Historic Architectural Review Commission Staff Report for Item 5

Application Number: C2025-0032

Address: 1321-1325 Simonton Street and 625 South Street

Second Reading - Major Development Plan - Demolition of existing commercial buildings, parking lot, and pools.

Existing Site Plan. Hatched areas outlined proposed to be demolished.

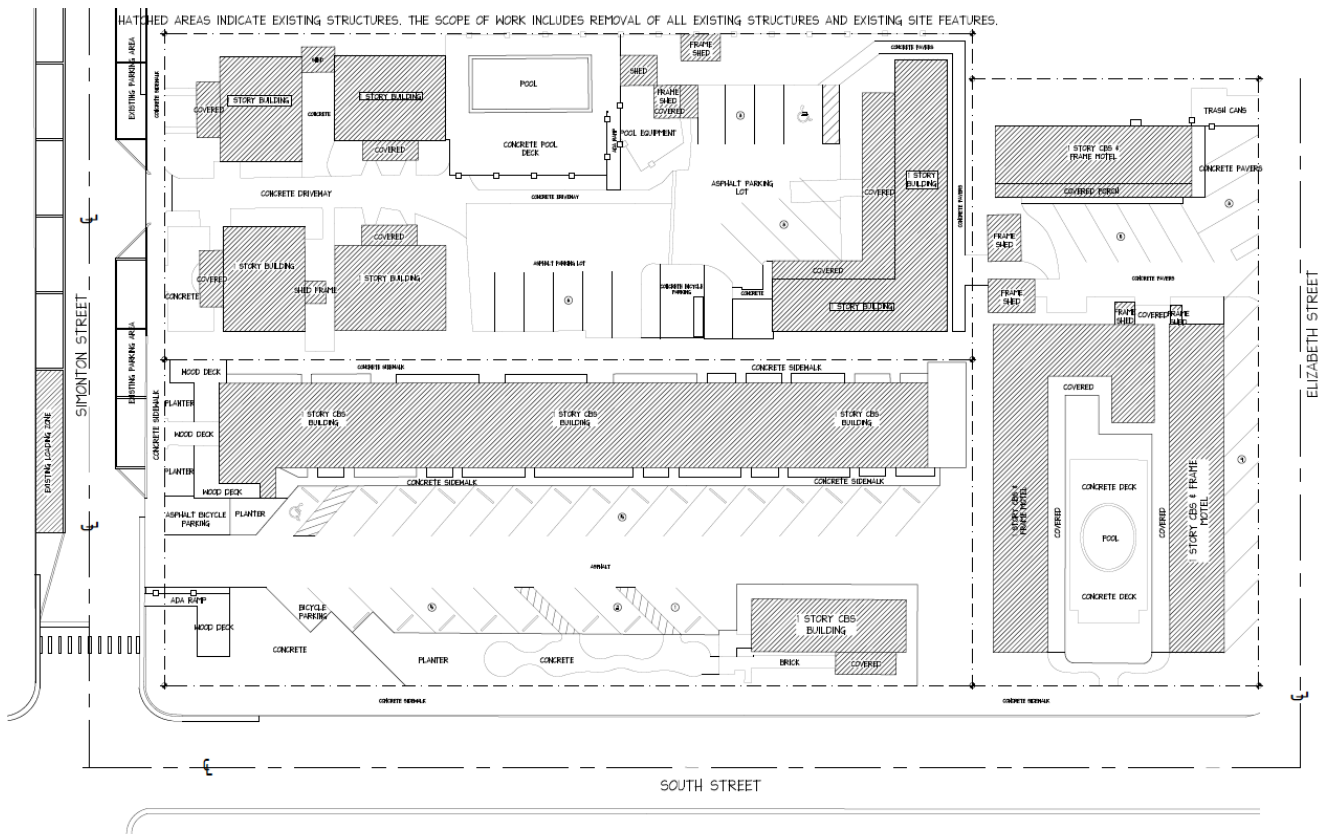
The Certificate of Appropriateness proposes the demolition of multiple one-story commercial buildings, concrete block structures, two swimming pools with surrounding concrete decks, and various site features. The scope of work includes the removal of all existing structures and hardscape elements across the three parcels, including asphalt parking lots, wood decks, bike racks, concrete walkways, landscape planters, and fencing.

Elements proposed for demolition are considered contributing (Southwinds Motel) and/or historic (remaining structures), but staff has found no evidence of extreme deterioration that would make them structurally unsalvageable.

It is staff's opinion that the request for demolition may be considered, as the structures under review meet the criteria for demolition. While identified the Southwinds Hotel at 1321 Simonton Street is classified as contributing and the rest of the buildings are historic, they do not exhibit distinctive characteristics or associations that would warrant retention. If approved, the demolition will require two readings, as required for contributing structures within the historic district. Staff will review submitted construction plans for demolition and design to ensure consistency with submitted drawings.
